DEVIATION REQUEST AND DECISION FORM

Project Name :	The Commons at Falcon Field	Deviation No. 3	Date: 2/9/2024 rev. 4/3/2024
Schedule No.(s) :	4307000001 and 4307200015		
Legal Description :	<p>TRACT IN SEC 7-13-64 DESC AS FOLS: BEG AT NW COR OF LOT 13 ARROWHEAD ESTATES FIL NO 1; TH S 00<46'12" W 197.28 FT ALG WLY LN OF SD LOT 13 TO A PT, N 41<58'50" W 798.01 FT TO SELY R/W LN OF US HWY 24, TH ALG SD SELY R/W LN ALG ARC OF CUR TO L SD CUR BEING CONCAVE TO NW HAVING A RAD OF 5800.00 FT AN ARC DIST OF 193.53 FT A C/A OF 01<54'42" WHICH CHORD BEARS N 47<22'56" E 193.52 FT, N 46<25'11" E 760.04 FT TO INTSEC SD SELY R/W LN OF US HWY 24 & WLY R/W LN OF RIO LN, TH SLY ALG SD R/W OF RIO LN S 22<22'28" E 219.81 FT, S 89<10'21" E 1071.23 FT TO NW COR OF LOT 14 OF FALCON RANCH ESTATES SUB, S 00<10'51" E 705.04 FT ALG WLY LN OF SD LOT 14 & LOT 13 FALCON RANCH ESTATES SUB TO THE MOST NLY NW COR OF LOT 10 ARROWHEAD ESTATES FIL NO 1, TH CONT S 00<10'51" E 151.74 FT, TH N 88<55'44" W 1314.29 FT TO POB</p> <p>TRACT IN SEC 7-13-64 DESC AS FOLS: COM AT NW COR OF LOT 13 ARROWHEAD ESTATES FIL NO 1; TH S 00<46'12" W 197.28 FT FOR POB; TH CONT S 00<46'12" W 988.14 FT, S 86<00'46" W 327.52 FT, S 00<25'05"

Deviation Exhibit 1-2

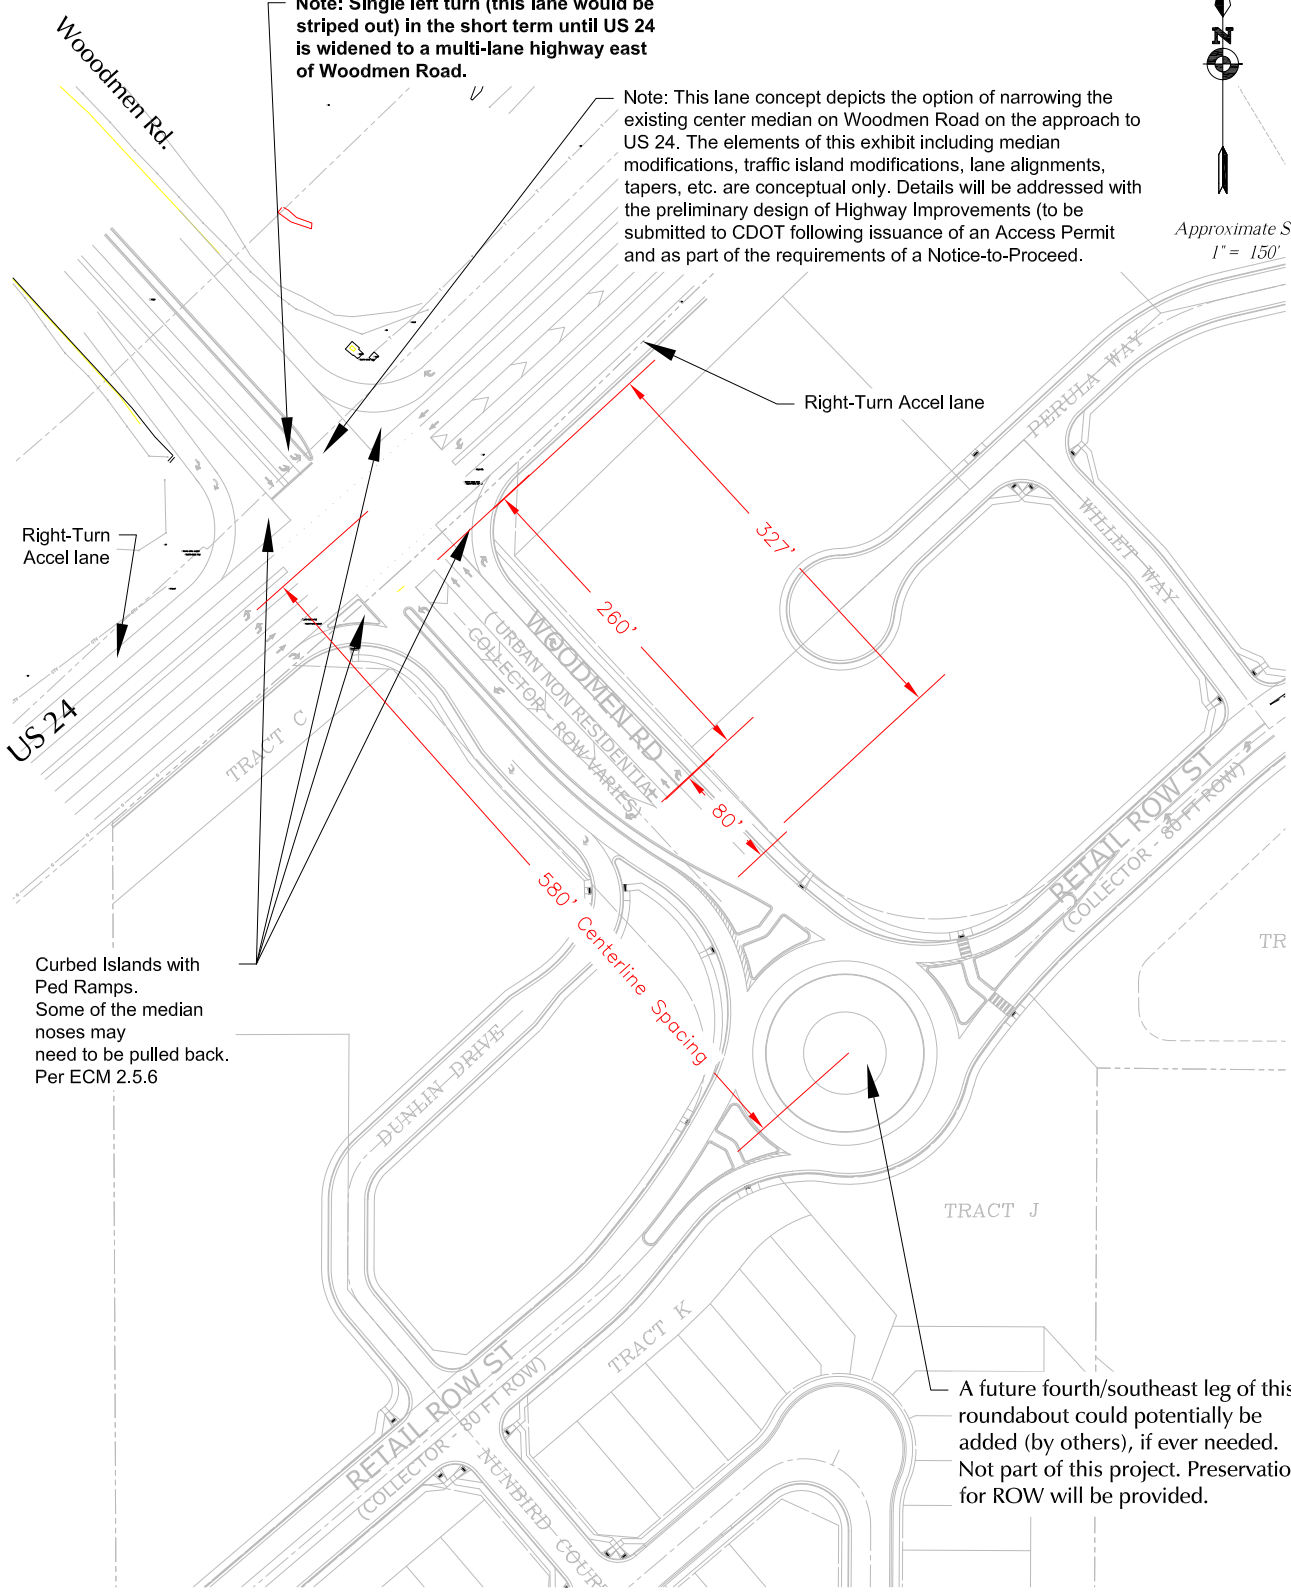
- The 2043 horizon year queueing analysis indicates that the proposed left-turn lane lengths for the northbound approach to the Woodmen Road/US Highway 24 intersection will be able to accommodate the projected queues. The queue lengths shown on Deviation Exhibit 3-3 would not exceed the lane-length dimensions shown on Deviation Exhibit 1-2.

Deviation Exhibit 3-1

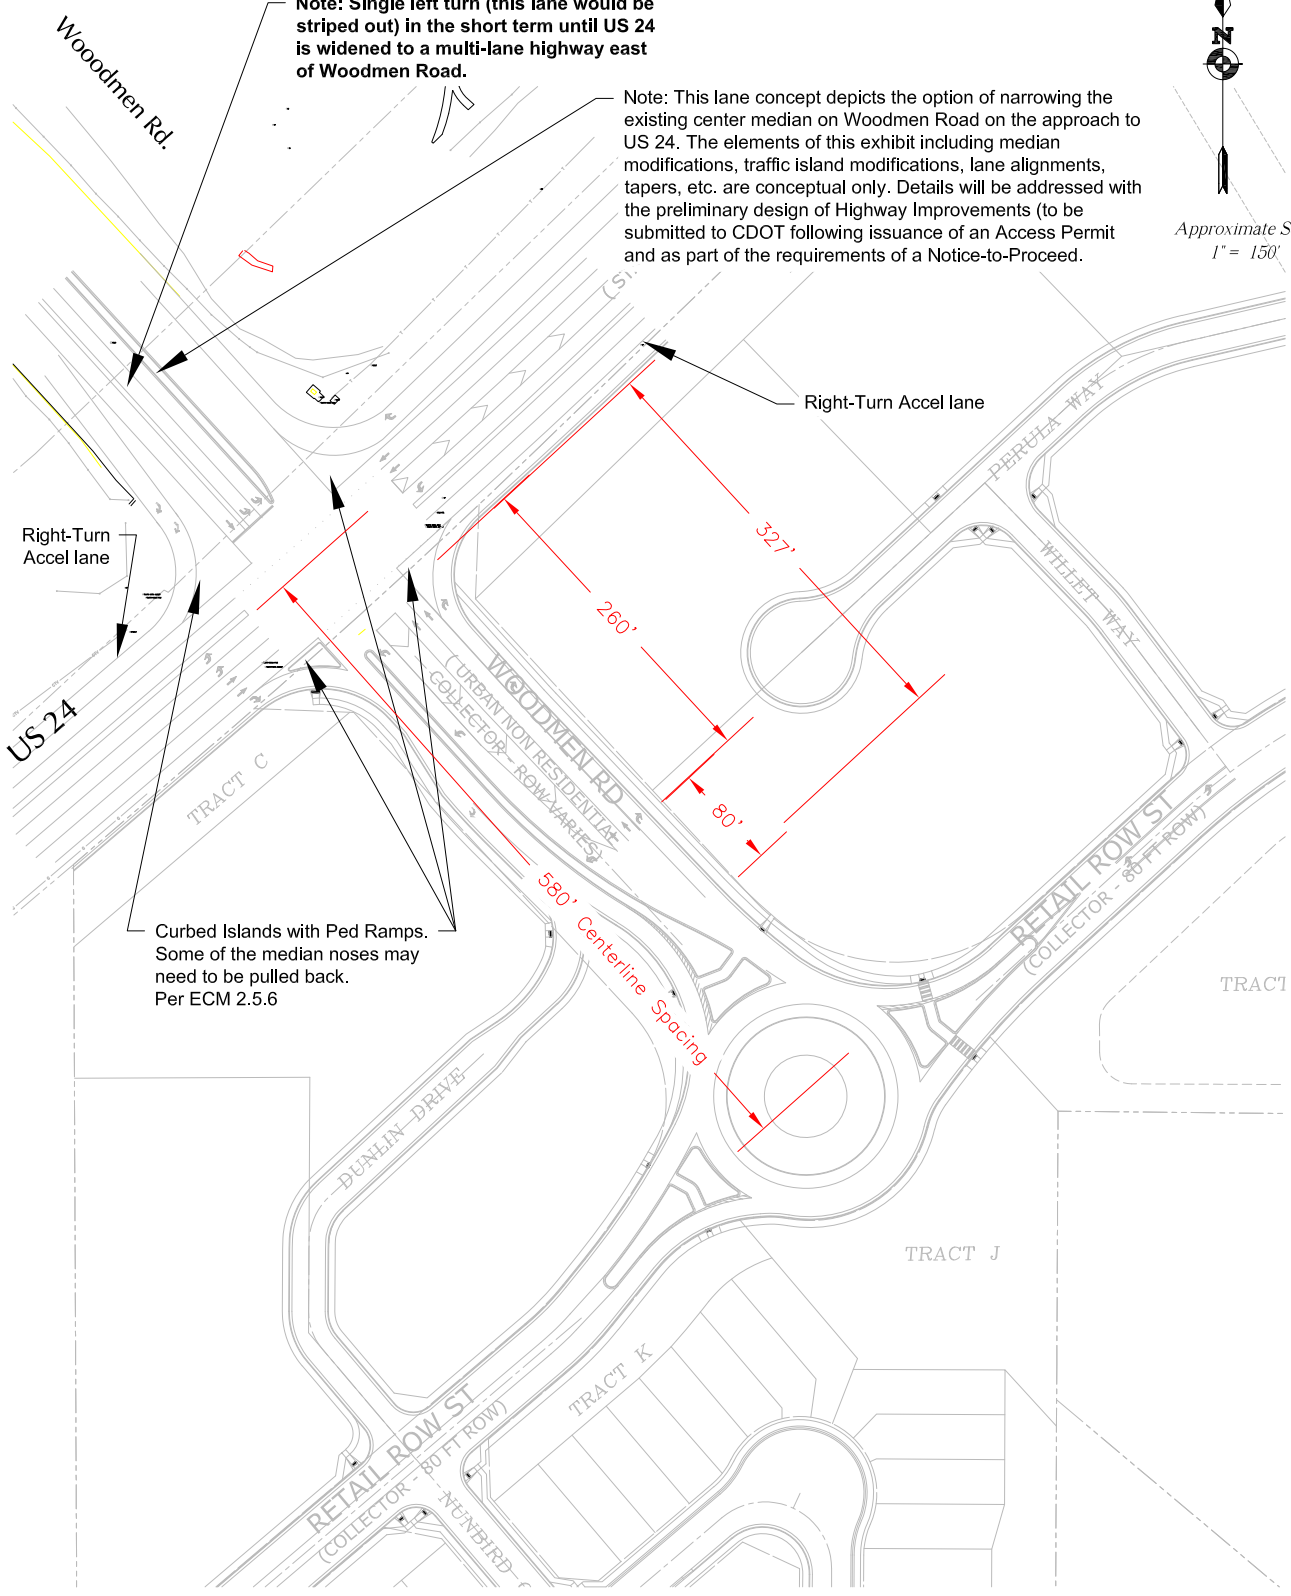
This deviation is one of four submitted with this application. Deviation Exhibit A (attached) graphically summarizes all four deviation requests, including this one. Please refer to the attached Deviation Exhibits 3-1, 3-2, and 3-3 which graphically show this Deviation request No. 3. Queue analysis report printouts are also attached, for reference.

- Please refer to the attached Deviation Exhibits 3-1, 3-2, and 3-3. The request requires a deviation as the ECM prescribes deceleration length plus vehicle storage distance plus transition taper for left-turn lanes on Collector roadways where turn lanes are required per section 2.3.7.D.1.

Deviation Exhibit 3-2

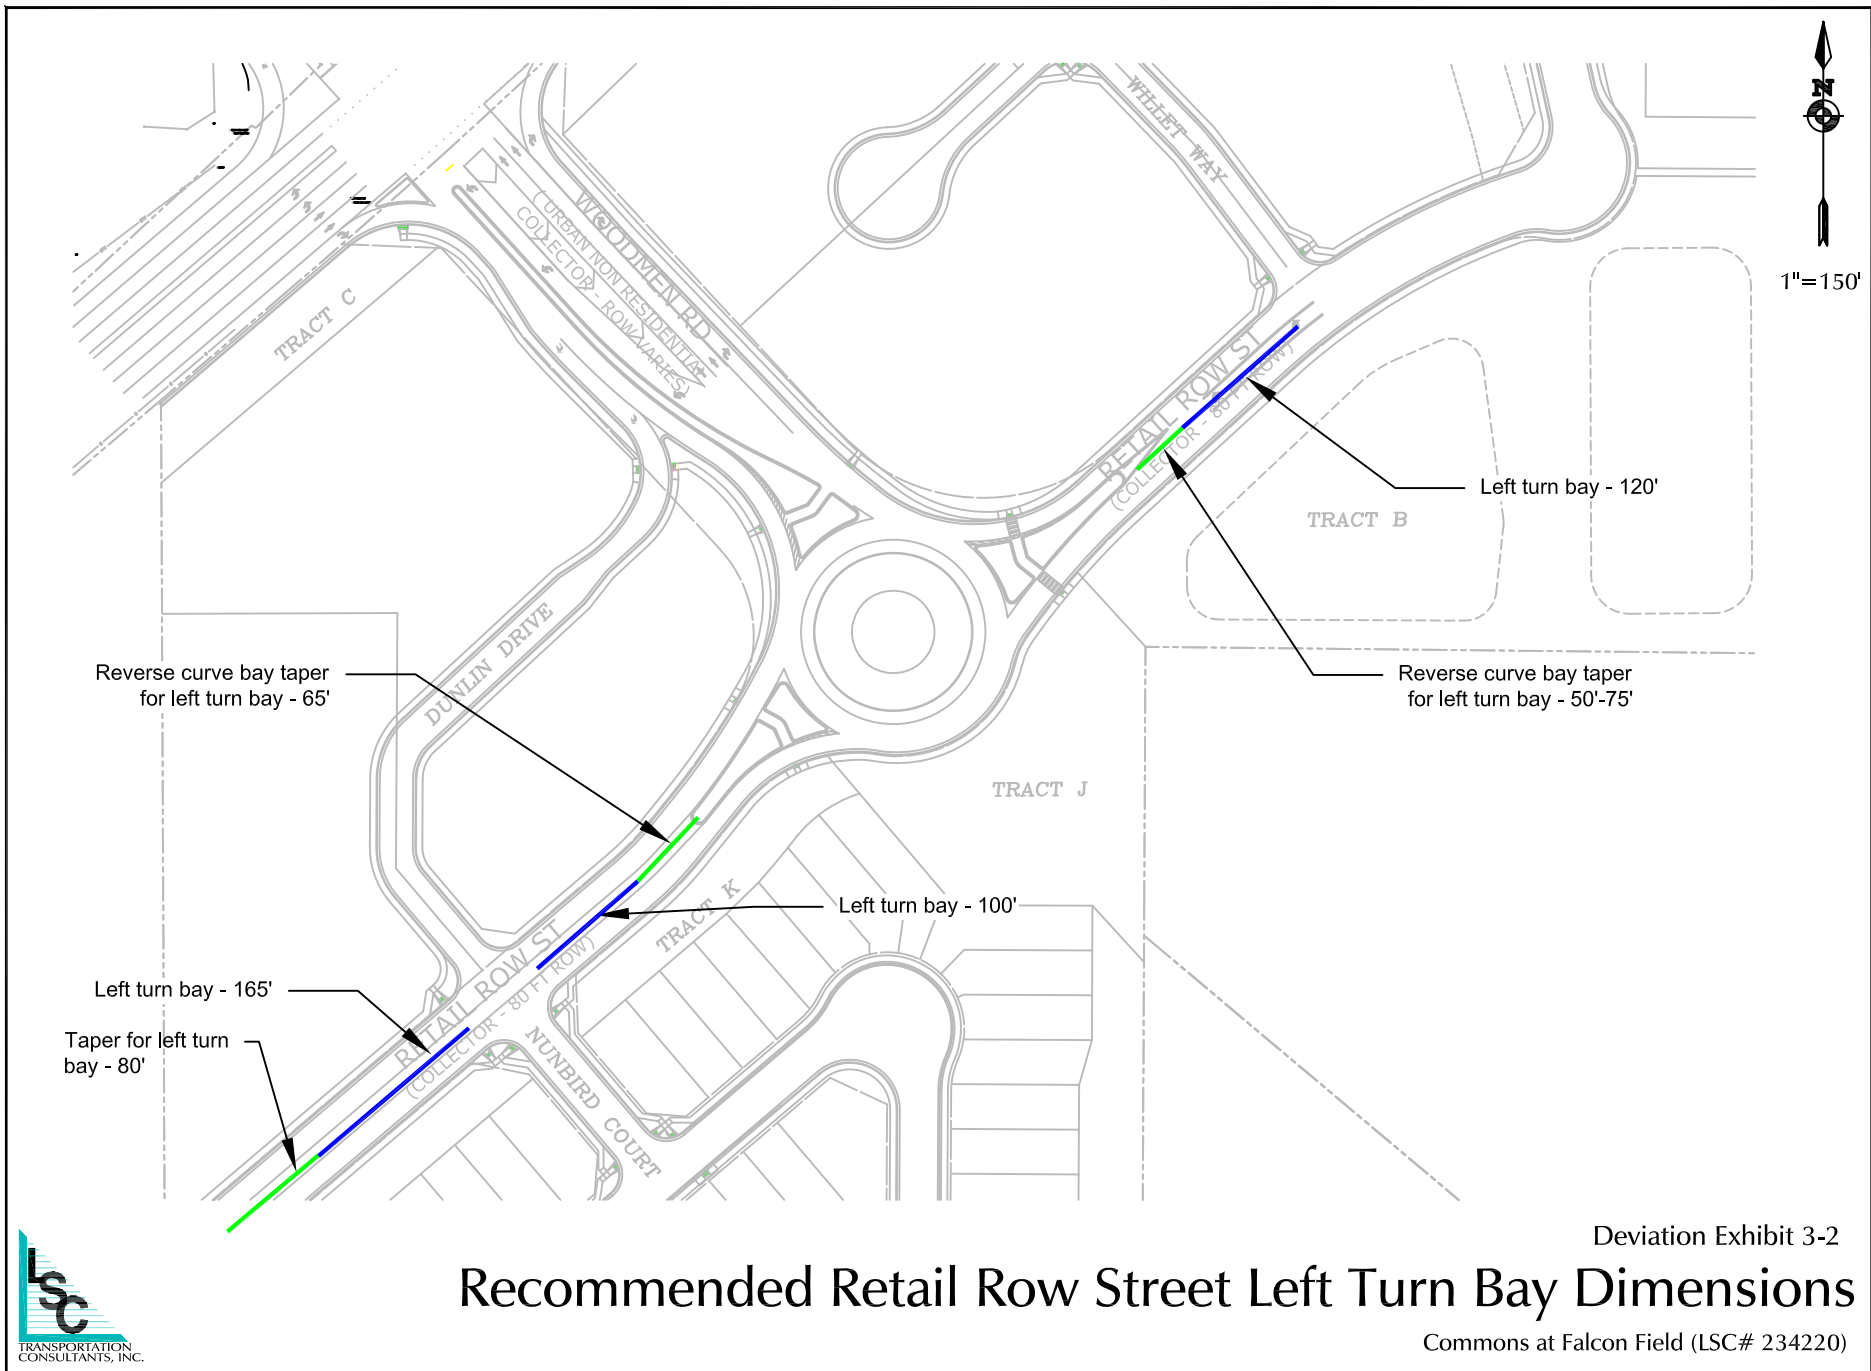
The proposed right-turn lane would have abbreviated lane and taper lengths. The ECM standard is 115-foot lane plus 80-foot bay taper, plus storage. Deviation Exhibit 3-2 shows the proposed lengths. The lane would be about 130 feet plus a 55-foot bay taper. The abbreviated length will be mitigated by the proposed custom, compound corner radius.

As the upstream intersection adjacent to the two full-movement access points and Woodmen/US Highway 24 for which the subject turn lanes are requested and the approach to US Highway 24/Woodmen Road is planned as a modern one-lane roundabout, back-to-back left-turn lanes along these Non-Residential Collector streets will not be required. Please refer to Deviation Exhibit 3-2.

The turn-bay lengths on the approach to Woodmen/US Highway 24 are a function of the spacing between Woodmen and the proposed roundabout, and the spacing between the intersections is constrained. Please refer to Deviation Exhibit 3-2 for the proposed turn-bay lengths and Deviation Exhibit 3-3 for the estimated queue lengths. The distance is constrained by the roundabout location which is limited due to the shape of the properties and the locations of the property lines. Please refer to the separate Deviation No. 1 for intersection spacing.

This request has been determined to have met the criteria for approval. A deviation from Section 2.3.7.D.1 of the ECM is hereby granted based on the justification provided.
